# United States Patent and Trademark Office

APPLICATION NO.	F	LING DATE	FIRST NAMED INVENTOR	ATTORNEY DOCKET NO.	CONFIRMATION NO.
10/801,225	+	03/16/2004	Dirk Weichholdt	09242-US	2010
30689	7590	03/02/2006		EXAMINER	
DEERE & ONE JOHN		· · <del>-</del>	KOVACS, ARPAD F		
MOLINE, IL 61265				ART UNIT	PAPER NUMBER
				3671

## **DETAILED ACTION**

- (b) the invention was patented or described in a printed publication in this or a foreign country or in public use or on sale in this country, more than one year prior to the date of application for patent in the United States.
- 2. Claims 1-8, 11-17 are rejected under 35 U.S.C. 102(b) as being anticipated by Roberg (EP 0631717 A1).

chopper fig 9, as it is shown in the marked up drawing below;

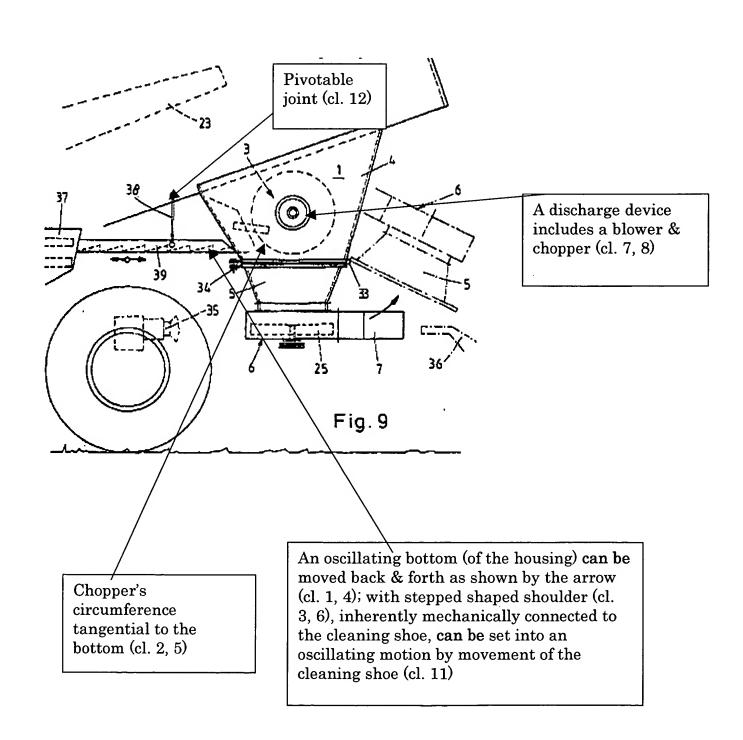
it is noted in re cl. 1 & 4, that the rotatable chopper (ref 3) receives material from left side, just below the counter blade / shear blade (shown in fig 9), therefore the step shaped shoulder or vibrating toothed conveyor is in the same housing;

the housing bottom / floor (39) is connected to the harvesting machine by means of an oscillating rocker (38) so that the function of: can oscillate in a direction Application/Control Number: 10/801,225 Page 3

of motion-back and forth (see arrow in fig 9) for feeding residual crop material through the chopper (i.e. the back and forth motion can and capable of feeding material through the chopper);

direction of motion is tangential to the circumference of the chopper (1) & also, see drawing below;

step shaped shoulder at a front end of the bottom / floor for improved pushing of material through the chopper (note: without the step shaped shoulder the material would not as aggressively move through the chopper; also, see drawing below);

see drawing below;

as best shown in fig 9, or drawing below, the connection between the housing bottom & the shoe is mechanical, and the shoe is capable of setting the housing bottom into oscillating motion as shown by the left & right arrows;

pivotable joint as shown in the drawing below;

an oscillating floor bottom of the cleaning assembly (37) is rigidly connected to the housing bottom;
